RE: **Wilder Project, FERC No. 1892-026**
Bellows Falls Project, FERC No. 1855-045
Vernon Hydroelectirc, Project No. 1904-073

Preliminary License Proposal dated December 1, 2016
&
ILP Study 2 & Study 3, Riverbank Transect and Riverbank
Erosion Studies dated February 4, 2017

CONTENTS: Landowner's comments re the two above referenced documents submitted by TransCanada on December 1, 2016 and February 4, 2017.

Mudge fields, Lyme, New Hampshire, left, pre-1896 and right, about 1940. *Both show a strong and healthy riparian buffer with vegetation and a gentle slope to the river. No erosion.*

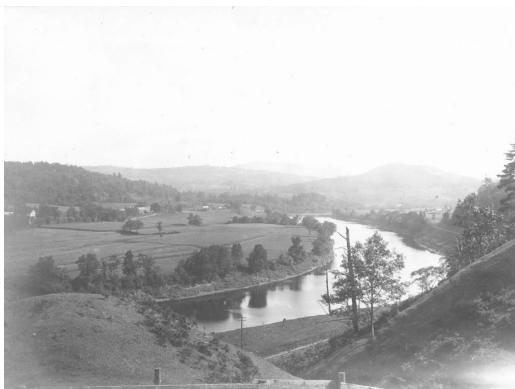
As the below two pictures show, there was no erosion on the Mudge farmland in the picture taken prior to 1896 and the other about 1940. As has been shown elsewhere, today there is tremendous erosion and the farmland shown in these pictures has lost forty (40) feet at the riverbank / farmland. The land is not disappearing beside the River Road. The land is disappearing at the banks of the Connecticut River! Acres of farmland have been lost.

Stumps of the old trees are to the left.
 Forty feet of riverbank lost.
 No erosion?
